REMARKS

2141 East Highland Avenue
155 Park One
Phoenix, Arizona 85016
(602) 956-7000
Docket No. 2973-A-34

AMENDMENTS TO THE DRAWINGS:

FIG. 3B

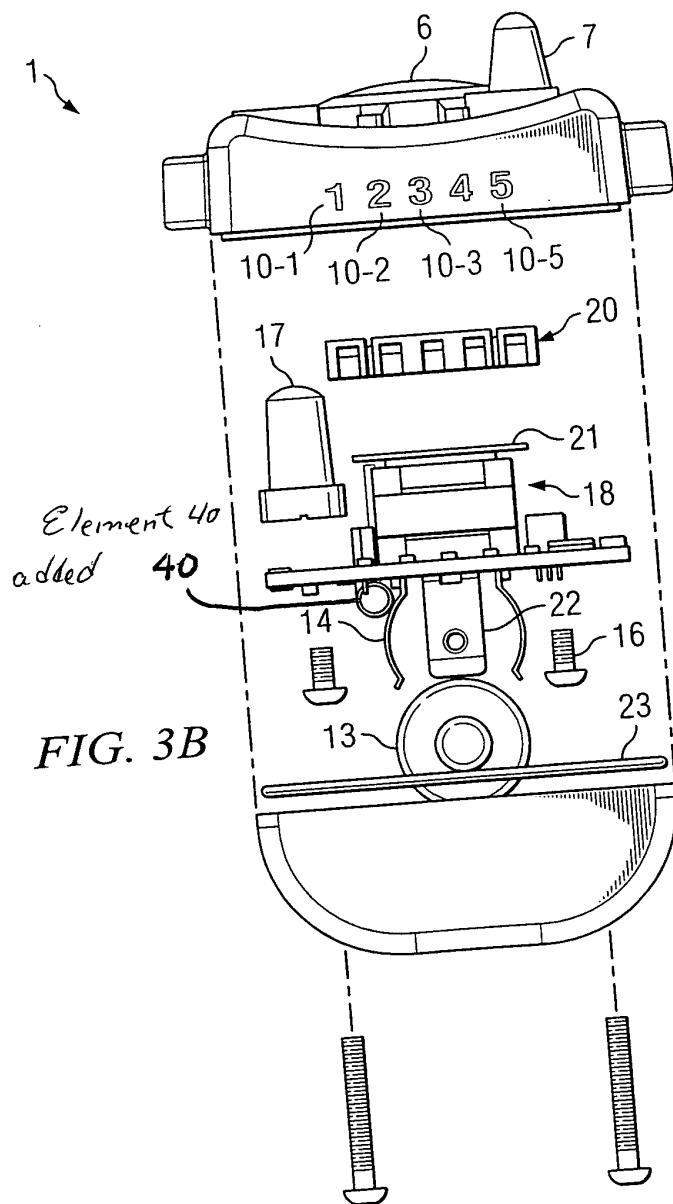
The drawings have been amended to add the reference numeral 40 that had inadvertently been left out of the drawings. Specifically, the reference numeral 40 was added to Fig. 3B as shown on the attached copy of Fig. 3B. The addition is shown in red. A replacement of the sheet containing Fig. 3B is also enclosed herewith.

The attached sheet of drawings (sheet 3/11) includes changes to Fig. 3B. This sheet replaces the original sheet for Fig. 3B. In Fig. 3B, previously omitted element 40 has been added.
